Product Change Notice (PCN)

PCN Number: PCN-0450005R-01

Product(s) Affected: MJ-3536N

PREVIOUS CUI DEVICES DETAIL / IMAGE	NEW CUI DEVICES DETAIL / IMAGE

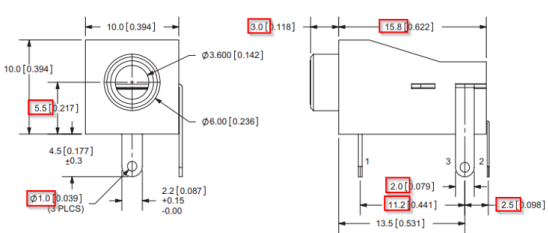
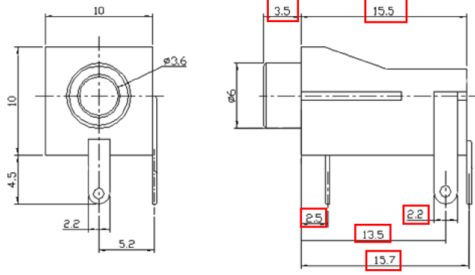
Description of Change: mechanical and material differences as shown below:

<p style="text-align: center;">PCB LAYOUT TOP VIEW</p>	 <p style="text-align: center;">Recommended PCB Layout Top View</p>																																				
<table border="1"> <thead> <tr> <th></th> <th>MATERIAL</th> <th>PLATING</th> </tr> </thead> <tbody> <tr> <td>terminal 1</td> <td>brass</td> <td>tin</td> </tr> <tr> <td>terminal 2</td> <td>copper alloy</td> <td>tin</td> </tr> <tr> <td>terminal 3</td> <td>brass</td> <td>tin</td> </tr> <tr> <td>bushing</td> <td>brass</td> <td>nickel</td> </tr> <tr> <td>plastic</td> <td>PBT</td> <td></td> </tr> </tbody> </table>		MATERIAL	PLATING	terminal 1	brass	tin	terminal 2	copper alloy	tin	terminal 3	brass	tin	bushing	brass	nickel	plastic	PBT		<table border="1"> <thead> <tr> <th>DESCRIPTION</th> <th>MATERIAL</th> <th>PLATING/COLOR</th> </tr> </thead> <tbody> <tr> <td>terminal 1</td> <td>brass</td> <td>silver</td> </tr> <tr> <td>terminal 2</td> <td>brass</td> <td>silver</td> </tr> <tr> <td>terminal 3</td> <td>brass</td> <td>silver</td> </tr> <tr> <td>bushing</td> <td>brass</td> <td>tin</td> </tr> <tr> <td>housing</td> <td>PA (LULB4V-0)</td> <td>black</td> </tr> </tbody> </table>	DESCRIPTION	MATERIAL	PLATING/COLOR	terminal 1	brass	silver	terminal 2	brass	silver	terminal 3	brass	silver	bushing	brass	tin	housing	PA (LULB4V-0)	black

MATERIAL	PLATING																																			
terminal 1	brass	tin																																			
terminal 2	copper alloy	tin																																			
terminal 3	brass	tin																																			
bushing	brass	nickel																																			
plastic	PBT																																				
DESCRIPTION	MATERIAL	PLATING/COLOR																																			
terminal 1	brass	silver																																			
terminal 2	brass	silver																																			
terminal 3	brass	silver																																			
bushing	brass	tin																																			
housing	PA (LULB4V-0)	black
